# SAN FRANCISCO PLANNING DEPARTMENT

## Discretionary Review Abbreviated Analysis HEARING DATE: MARCH 14, 2019

*Date:* February 28, 2019  
*Case No.:* **2016-006123DRP-02**  
*Project Addresses:* **279 Bella Vista Way**  
*Permit Applications:* 2016.0421.5348  
*Zoning:* RH-1[Residential House, Single-Family]  
40-X Height and Bulk District  
*Area Plan:* N/A  
*Block/Lot:* 2998/021  
*Project Sponsor:* Matt Hollis  
Matt Hollis Architects  
2325 Third St. suite 224  
San Francisco, CA 94107  
*Staff Contact:* David Winslow – (415) 575-9159  
[David.Winslow@sfgov.org](mailto:David.Winslow@sfgov.org)  
*Recommendation:* **Take DR and Approve with modifications**

The project consists of construction of a 228 s.f. horizontal rear addition at the ground level, and a 591 s.f. horizontal rear addition at the second floor of an existing 2-story, single-family dwelling.

(E) & (P) West  
Elevation  
SHEET NO.:  
**A2.03**

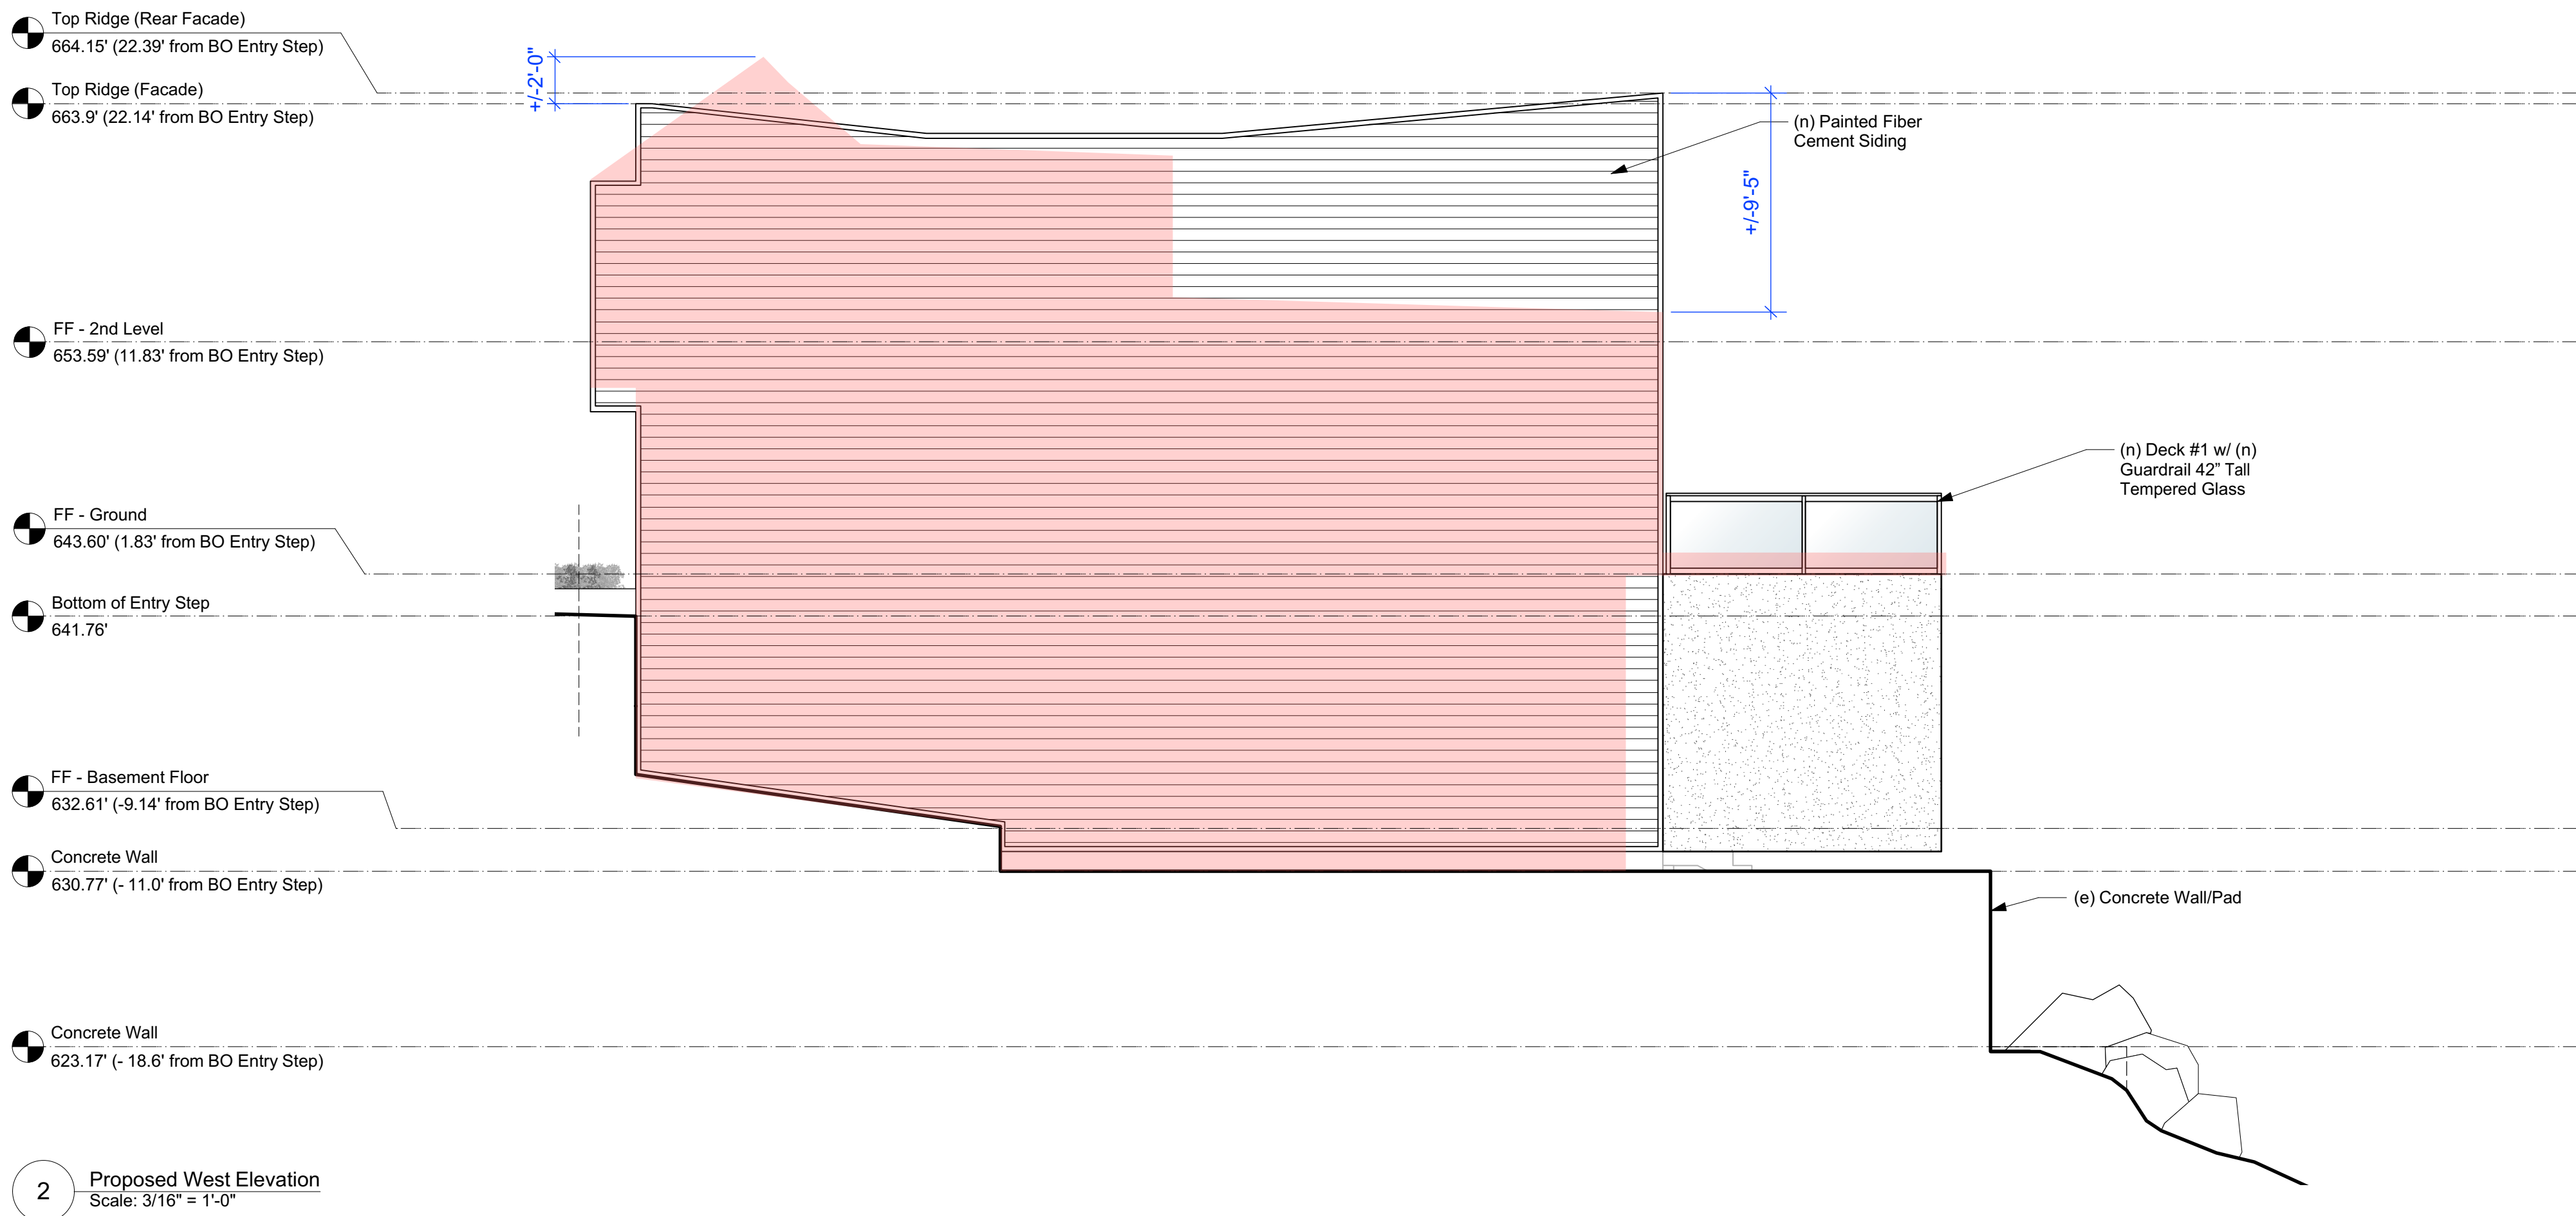
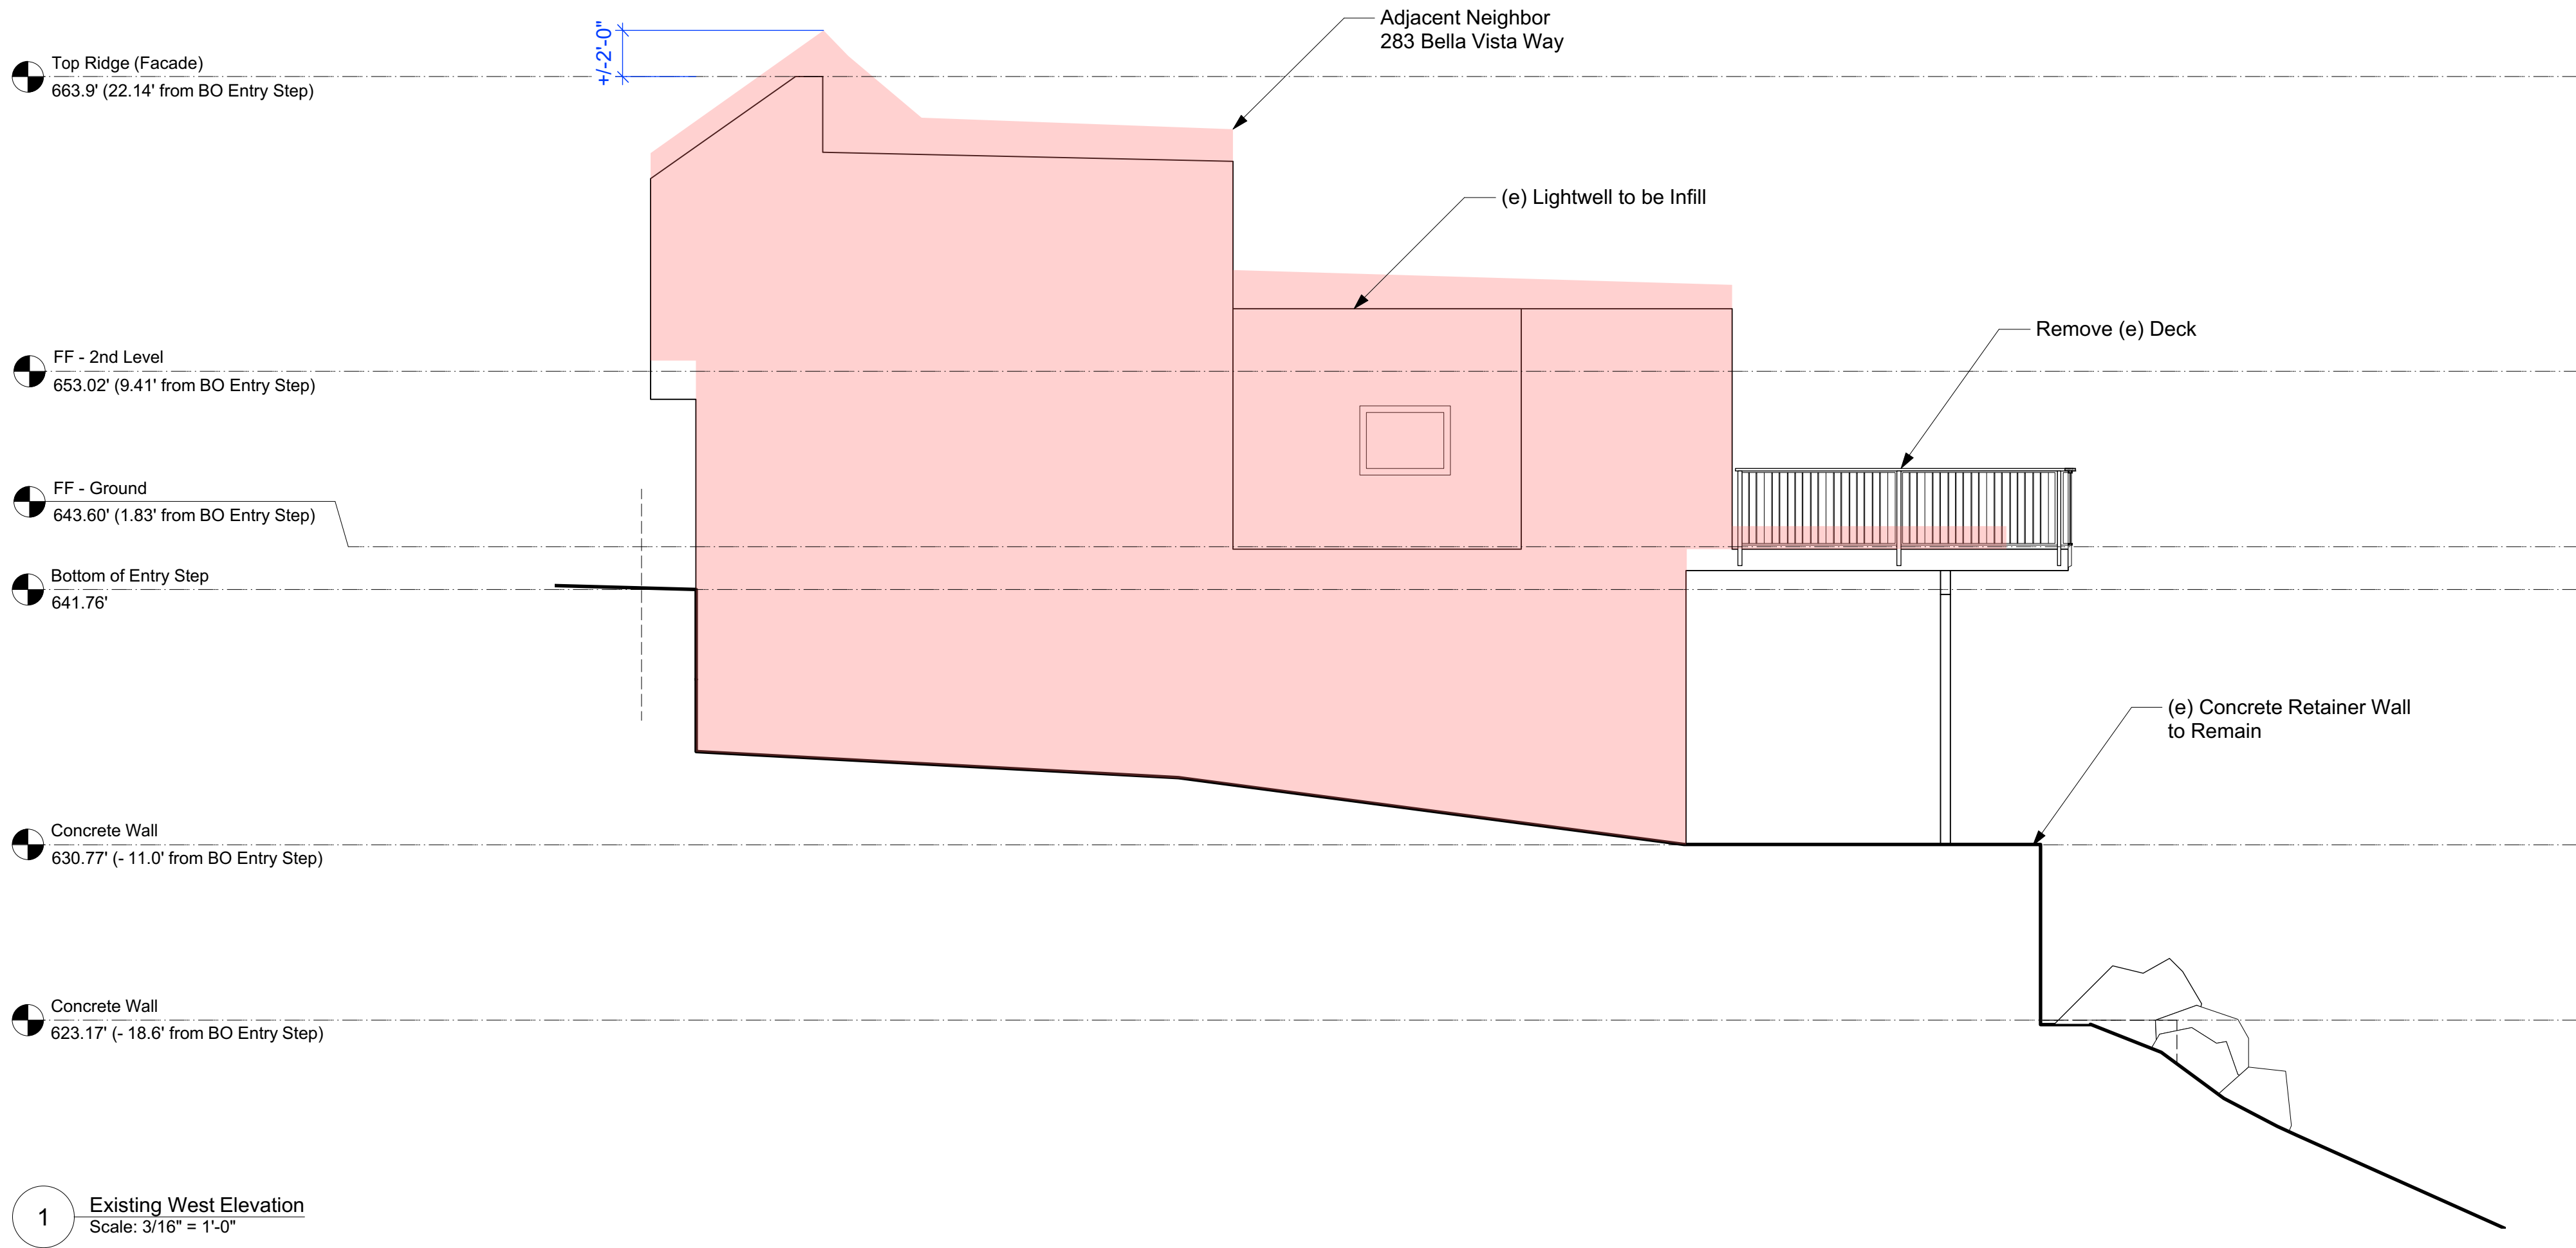
2. The elevation drawings on sheets A2.03 and A2.04 are mislabeled in terms of the directions they face and the proposed deck on the Proposed First Floor Plan on sheet A1.02, Deck #1, isn't labeled. Also, I don't see the profile of our houses on the elevation drawings. Finally, the elevations don't note the proposed finish materials on the sides of the addition. Therefore, I ask that the drawings be revised to provide this legibility.

4. Related to #7 below under Facade Remodel, the proposed side elevations on sheets A2.03 and A2.04 show that tall walls would be visible from my top floor. It's unclear from these drawings what ceiling height is proposed at the top floor or what the addition height would be above my roof. In order to lessen the scale and negative impact of the proposed top floor addition, I ask that the level of the second floor remain at the existing location, that the ceiling height at the top floor be no higher than 9' in order to make the addition more in scale with the adjacent buildings, and that the height of the addition above my roof be noted on the relevant elevation. Avoiding an oversized scale is addressed on page 39 of the MPRDG.

2. The elevation drawings on sheets A2.03 and A2.04 are mislabeled in terms of the directions they face and the proposed deck on the Proposed First Floor Plan on sheet A1.02, Deck #1, isn't labeled. Also, I don't see the profile of my house on the elevation drawings. Finally, the elevations don't note the proposed finish materials on the sides of the addition. Therefore, I ask that the drawings be revised to provide this legibility.

4. Related to #7 below under Facade Remodel, the proposed side elevations on sheets A2.03 and A2.04 show that tall walls would be visible from my top floor. It's unclear from these drawings what ceiling height is proposed at the top floor or what the addition height would be above my roof. In order to lessen the scale and negative impact of the proposed top floor addition, I ask that the level of the second floor remain at the existing location, that the ceiling height at the top floor be no higher than 9' in order to make the addition more in scale with the adjacent buildings, and that the height of the addition above my roof be noted on the relevant elevation. Avoiding an oversized scale is addressed on page 39 of the MPRDG.
